# PROPOSED WAREHOUSE DEVELOPMENT

**246 Miller Road, Villawood  
Riparian Management Advice**

SLR Ref: 630.30024-R01  
Version No: -v1.1  
June 2020

CD-A-163 and CD-A-164

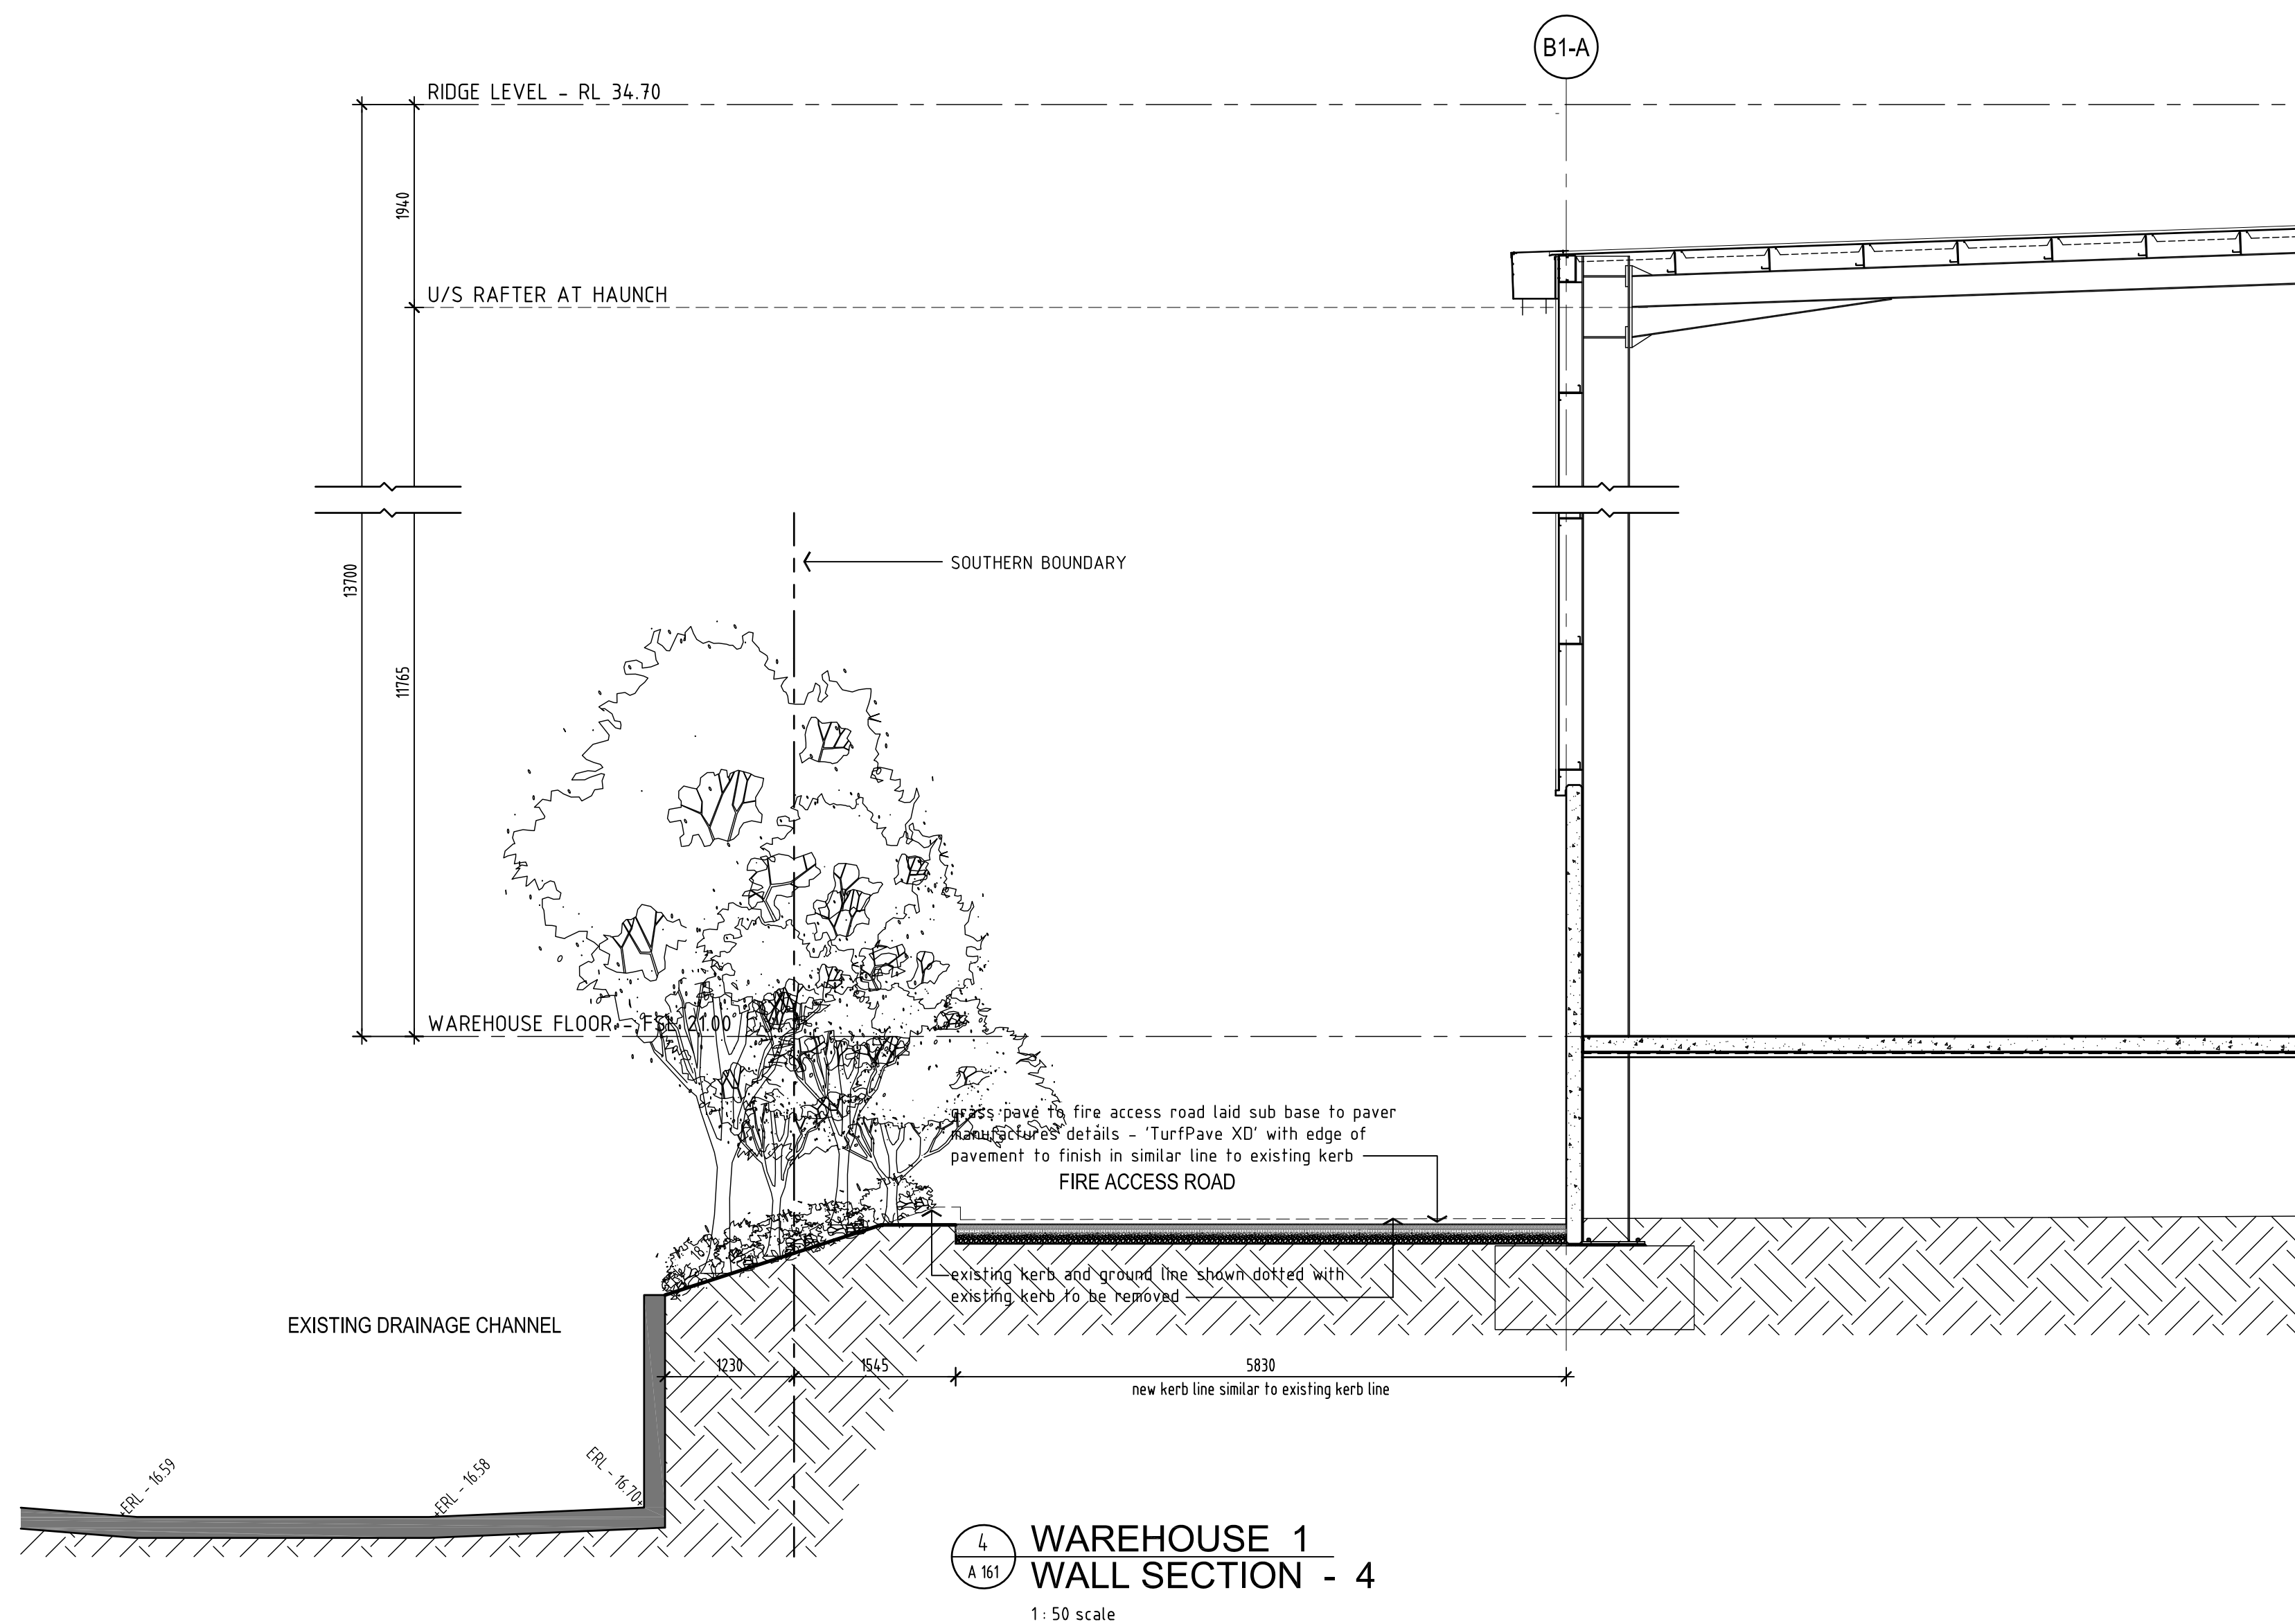
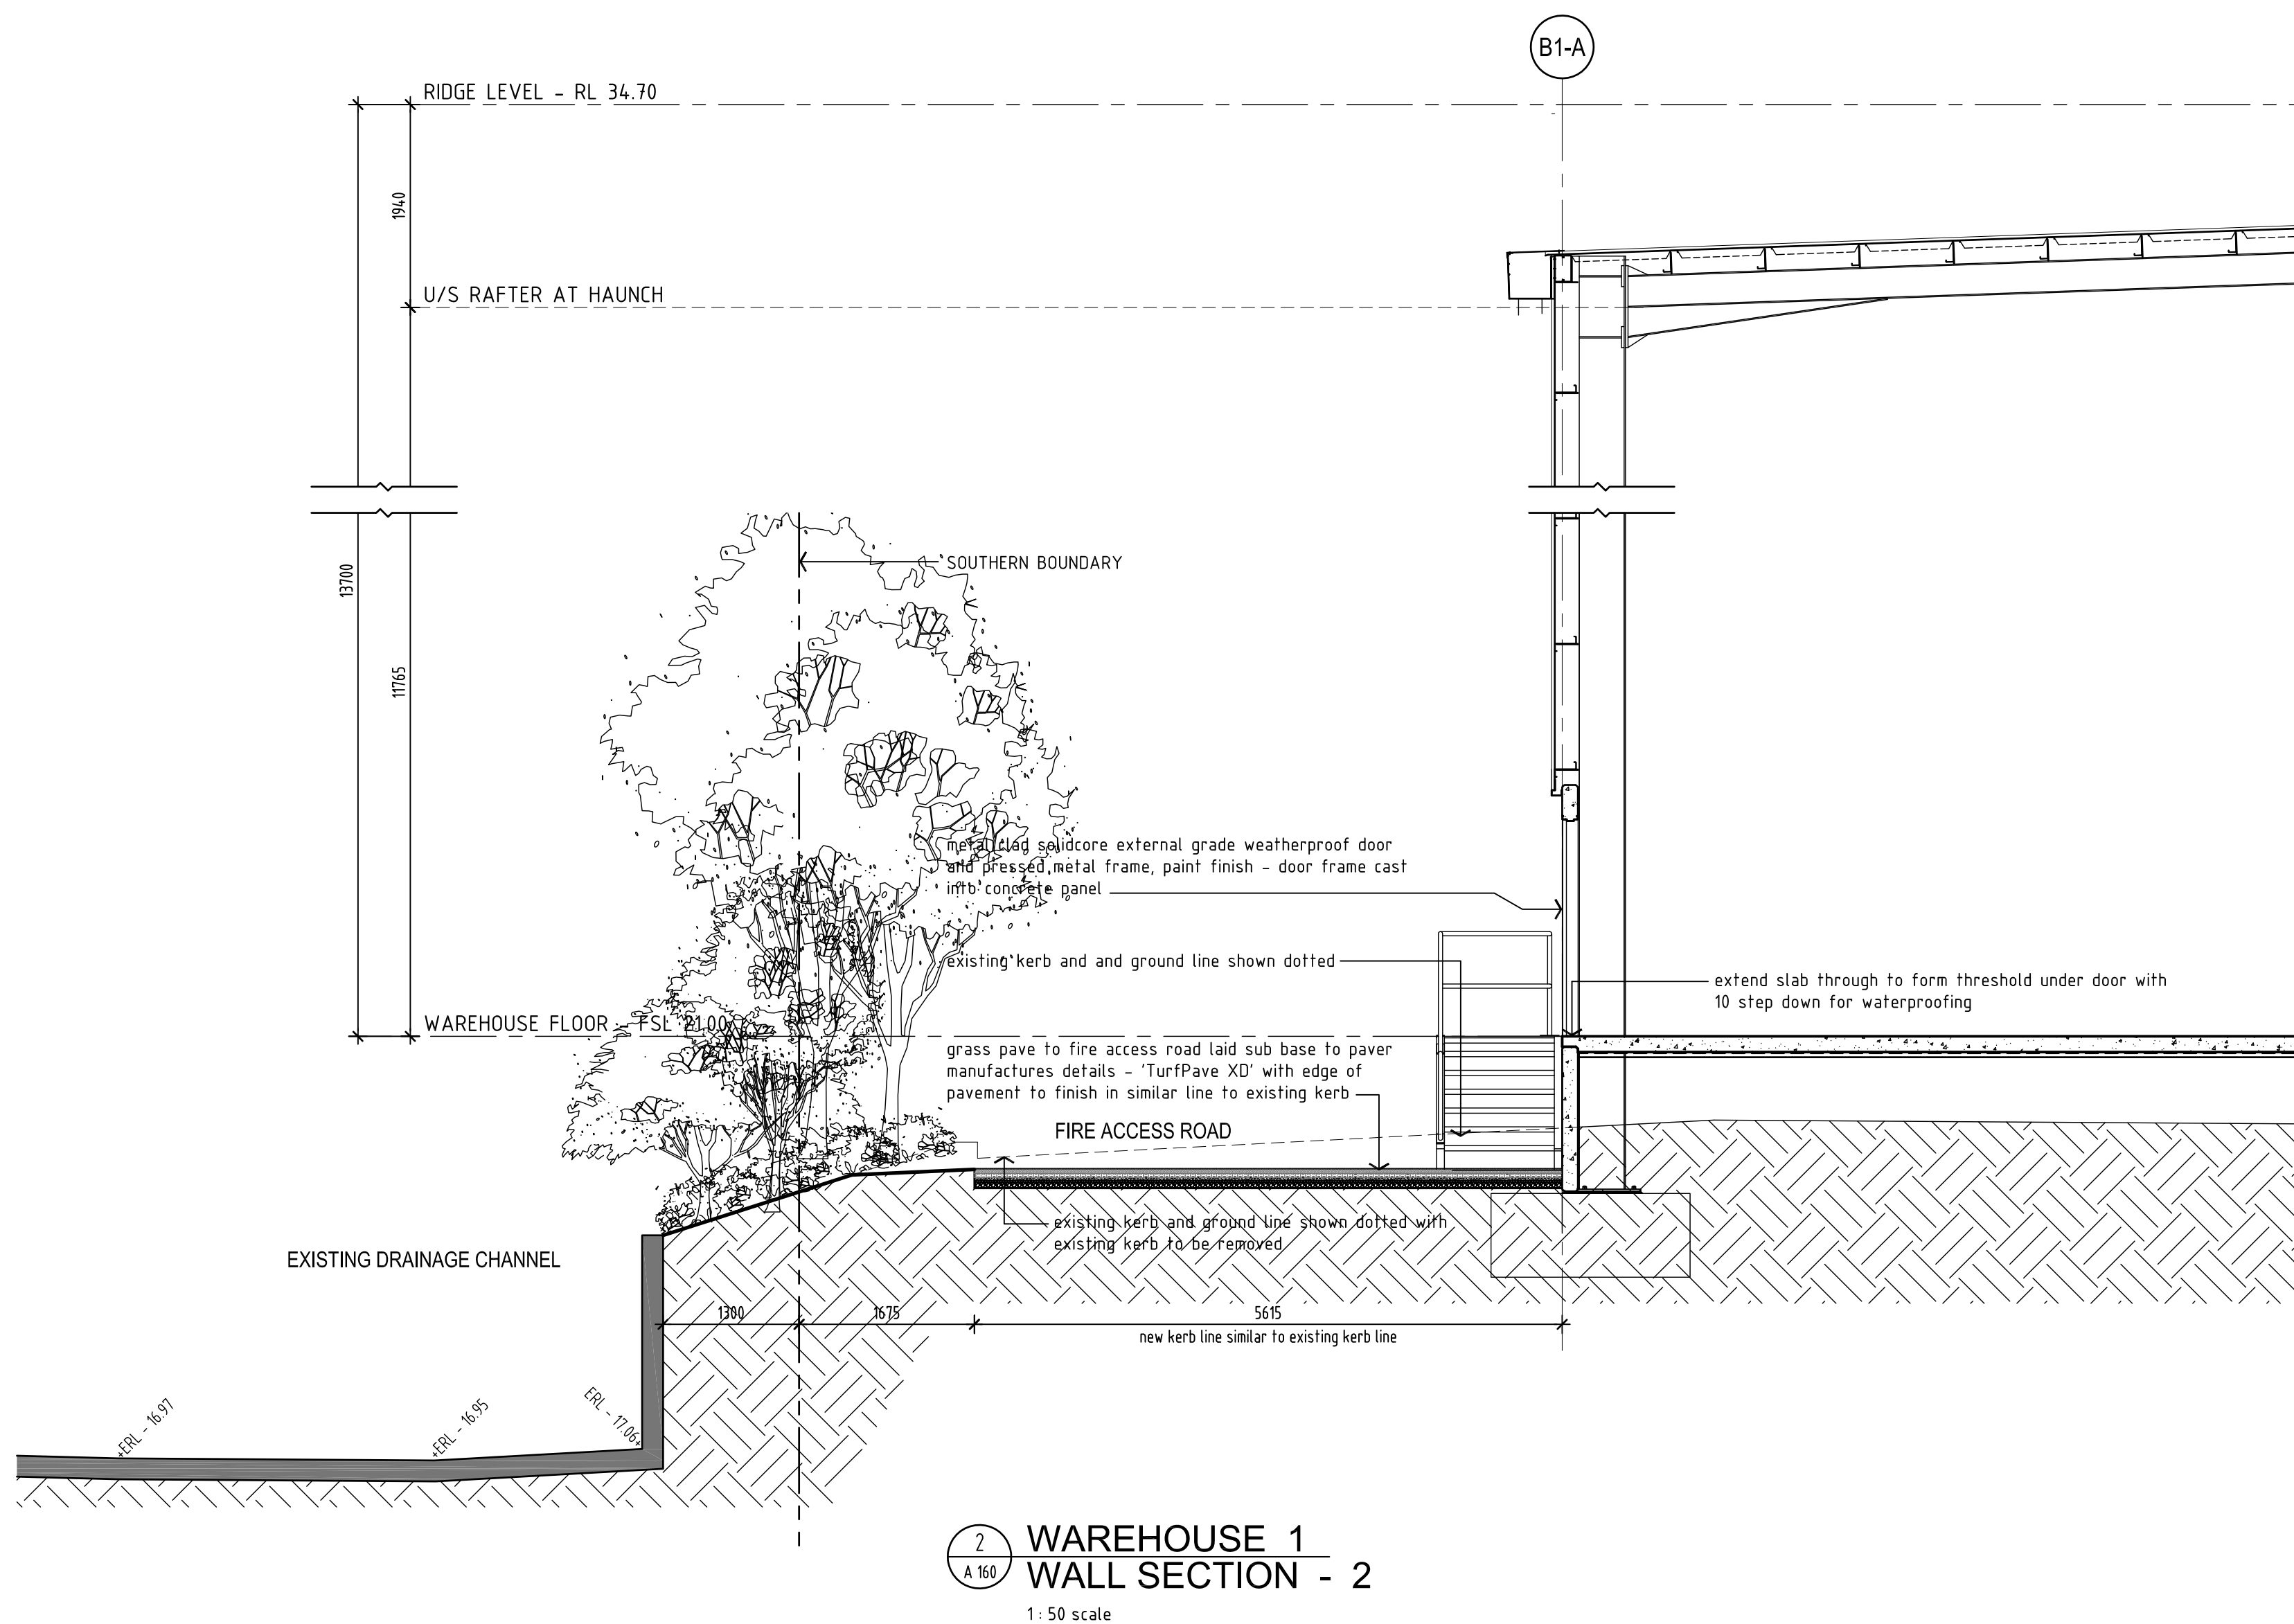
- Fire truck access road, which is a mandatory requirement to allow access for fire fighting vehicles. The amended proposal provides for a 5.675 m wide paved road, constructed of a permeable material (TurfPave XO).
- Vegetated Riparian Zone – between the fire access road, the southern site boundary and from the site boundary to the edge of the channel. This strip of land will be recontoured, with clean soil placed and planted with a selection of locally indigenous flowering plants (small trees, shrubs and groundcovers).

The total width of the proposed riparian zone extends from the top-of-bank of the channel to the edge of the proposed warehouse building with a total width of 8.6 m to 11.5 m (see **Appendix A**).

- Creates a vegetated riparian zone (or VRZ), consistent with NRAR guidance for waterfront land and with Clause 2.7 of the DCP, although it is acknowledged that the recommended width of the VRZ will not be 15 m as per the DCP or 10 m wide as per NRAR guidelines; the space limitations of the site and the design requirements of the proposed warehouse, as well as the requirements for a fire access road, do not allow a riparian corridor of greater width;

- Amend landscape plan to provide detailed drawing of proposed riparian planting area (i.e. vegetated riparian zone) along southern boundary;
- Create a 'vegetated riparian zone' between fire access road and channel bank, with imported clean substrate (sandy loam VENM soil or crushed sandstone) and plantings of local indigenous species; seek to maintain or rehabilitate the zone with fully structured native vegetation, in accordance with NRAR (2018) guidance;
